Limited Site Plan Amendment, High Acres, 82006022A

Report Date: 4/19/13

- Location: 6450 Brookes Lane
- Zone: R-90 Cluster
- Property Size: 4.4 acres
- Master Plan: Bethesda- Chevy Chase
- Limited Site Plan Amendment: Request to amend approved certified site plan to change lot lines, retaining wall, reconfigure driveway, recreational facilities, landscaping and lighting
- Applicant: Brookes Lane Development Company, LLC
- Filing Date: November 26, 2012
- **Staff Recommendation:** Approval with conditions

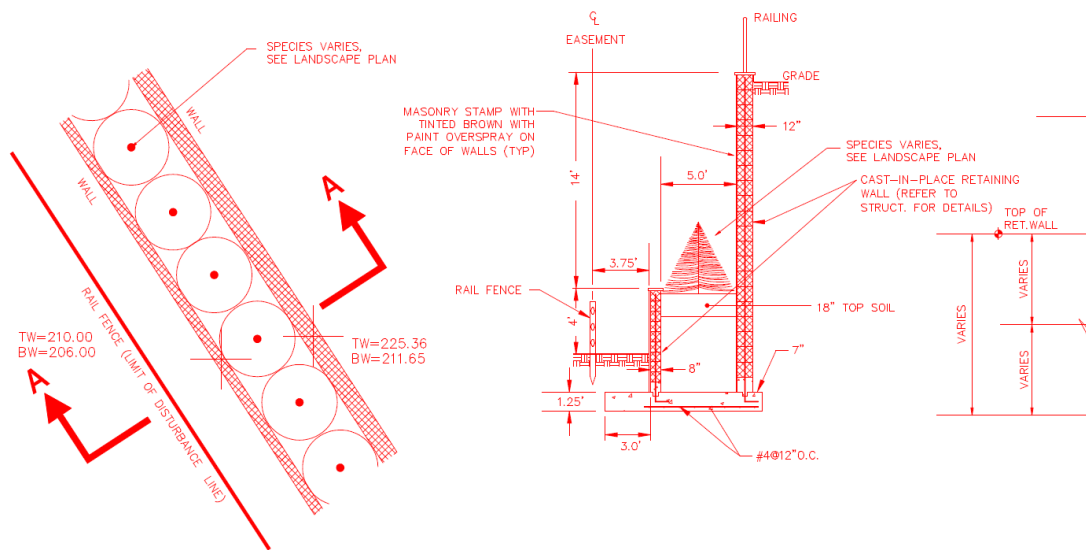
The original plan included the removal of Tree # 54 which is an approximately 32" dbh tree. In response to concerns raised by adjacent residents within the community. The applicant agreed to save the tree. Staff has included recommended conditions of approval to improve the tree save measures specified for Tree #54 that will help ensure its survival. The recommendations include the use of heavy-duty root

protection matting and specialized construction techniques for installation of 8" water line.

- iii. Clarify the tree preservation notes for Tree #54 and include improved tree preservation measures such as heavy duty temporary matting and specialized construction techniques for installation of the 8" water line.
